REPORT BY ACTING CITY PLANNER

17529. Proposed Transcendental Meditation Academy - Portion 207, Pulpit Hill Road, Katoomba (Radiata Plateau).

Development Application Report (Section 90 and Local Environmental Plan No. 4).

TITLE		MASTER PLAN	
DRAWING NO.	F901 SD 01		
SCALE	1:500		
DATE	NOVEMBER 1989		
DRAWN BY	L.A.1	CHECK BY	P.T. 0
THE ACADEMY AT INVINCIBILITY POINT (RADATA PLATEAU) FOR WORLD PLAN EXECUTIVE COUNCIL OF AUSTRALIA LTD.			
PETER OPPENHEIM ARCHITECT

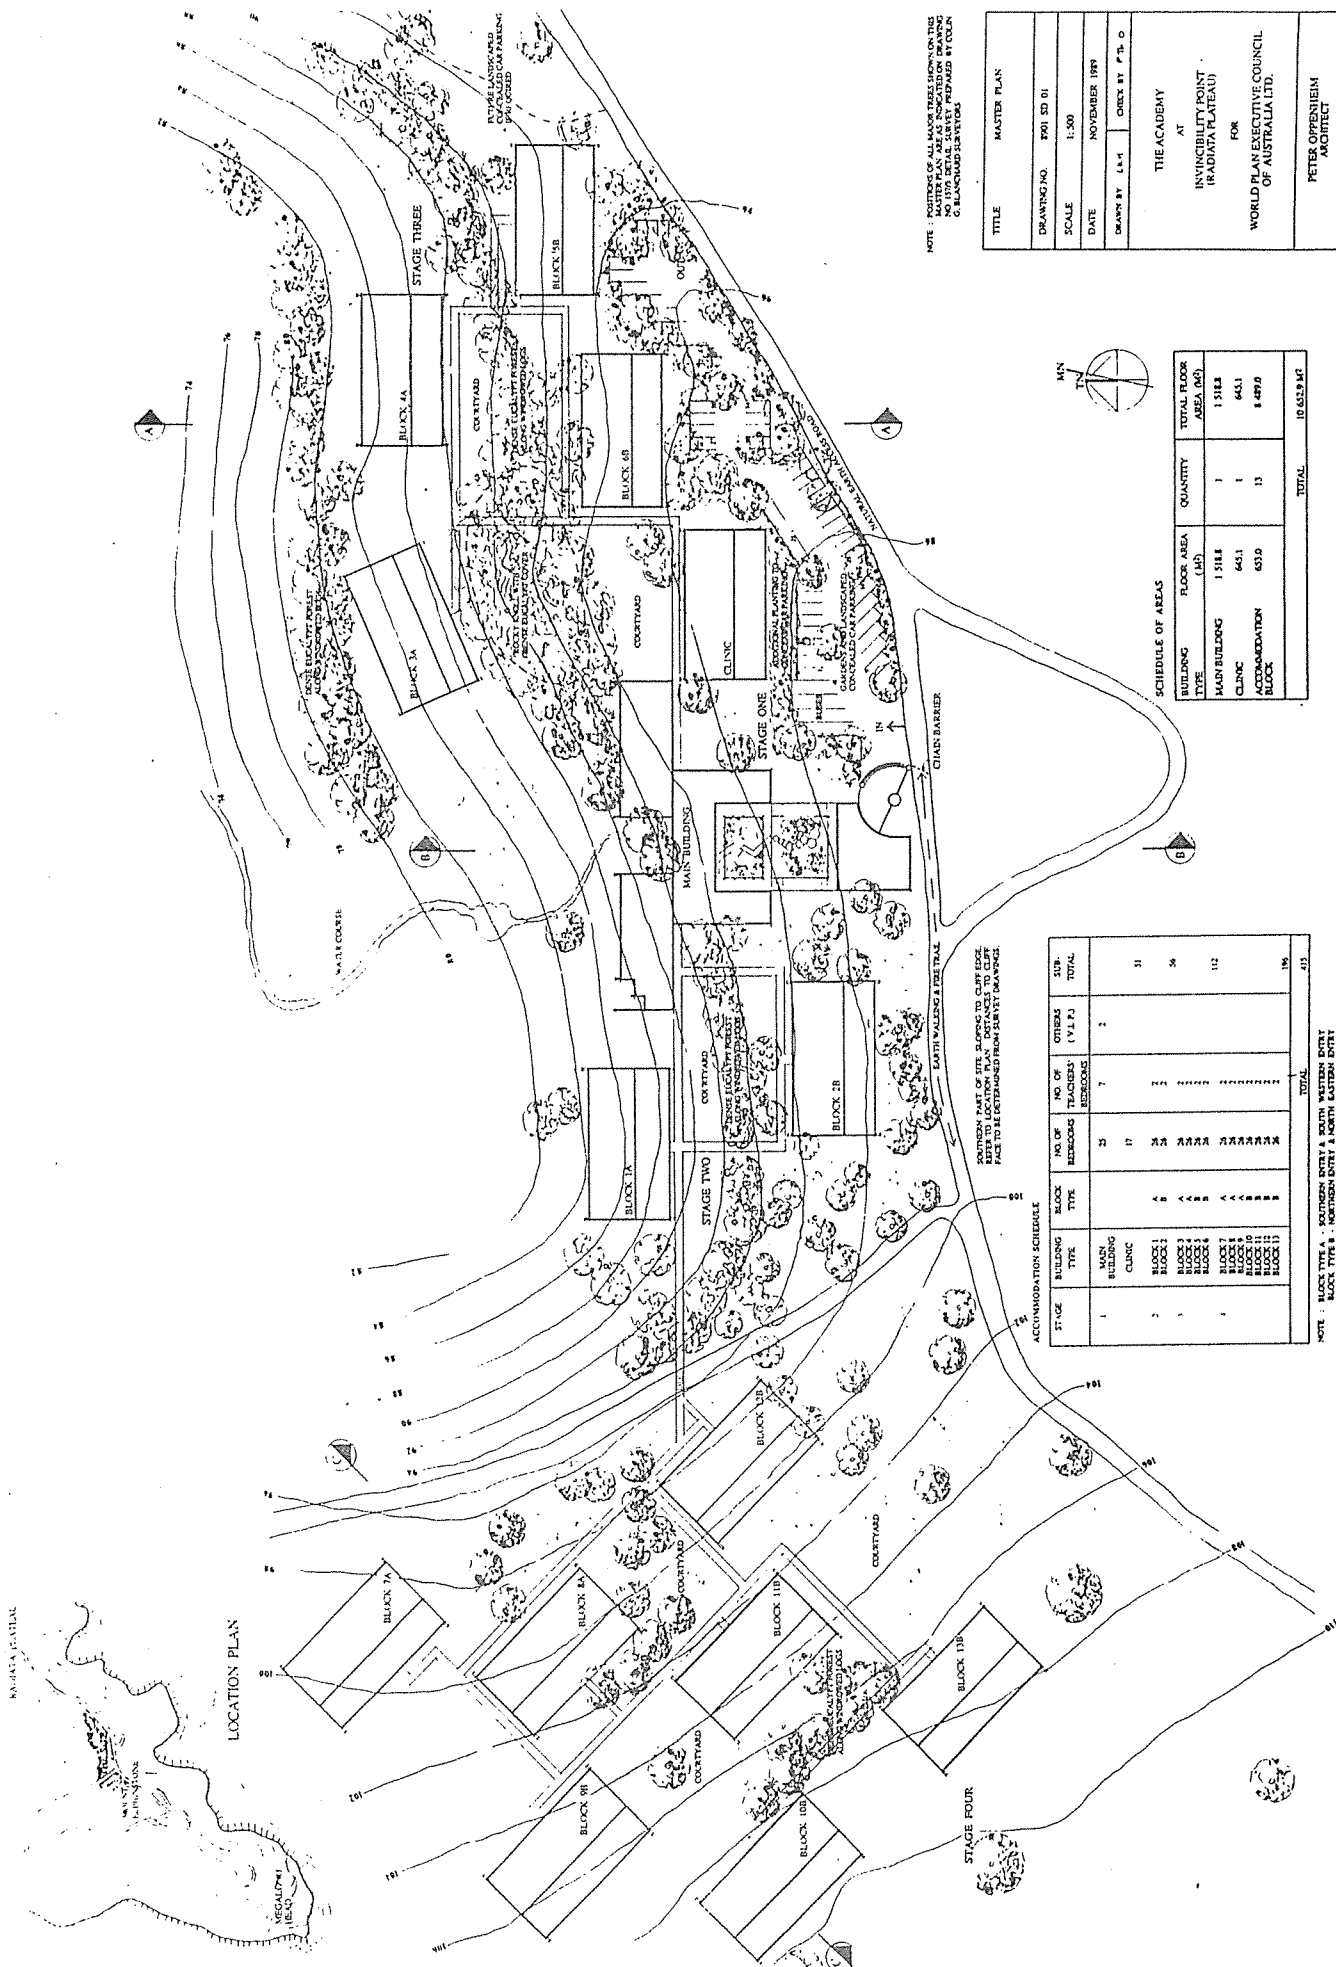
Detailed site inspections reveal that a minor re-orientation of the Main Building (Stage 1) will avoid steeper sloping land to the north-west. The applicant has agreed to accept this amendment.

The size of the ultimate proposal (415 rooms) causes concern. Although application is made for only Stage 1, it is important for Council and the community to know what the applicant ultimately has in mind.

Council should indicate that it does not favour development of more than 80 rooms, and that no development will be permitted in the location shown for Stage 4.

1. This consent relates to Stage 1 development only, as described in the Development Application.
2. All external materials of construction shall be dark earth tone colours of low reflective quality.
3. The completed building shall not, at any time, be substantially altered externally in character or colour without the consent of Council.
4. A schedule of colours and sample of all external building materials shall be submitted to the Town Planning Section for approval with the lodgement of a Building Application.
5. The buildings are to be re-orientated in accordance with amended plans dated 3rd May, 1990.

1. A further development application will be required for any further stage. Council considers that a total of 80 rooms is the maximum with no development on the area indicated for "Stage 4".
2. The applicant is reminded of his right of appeal under Section 97 of the Environmental Planning and Assessment Act, 1979.
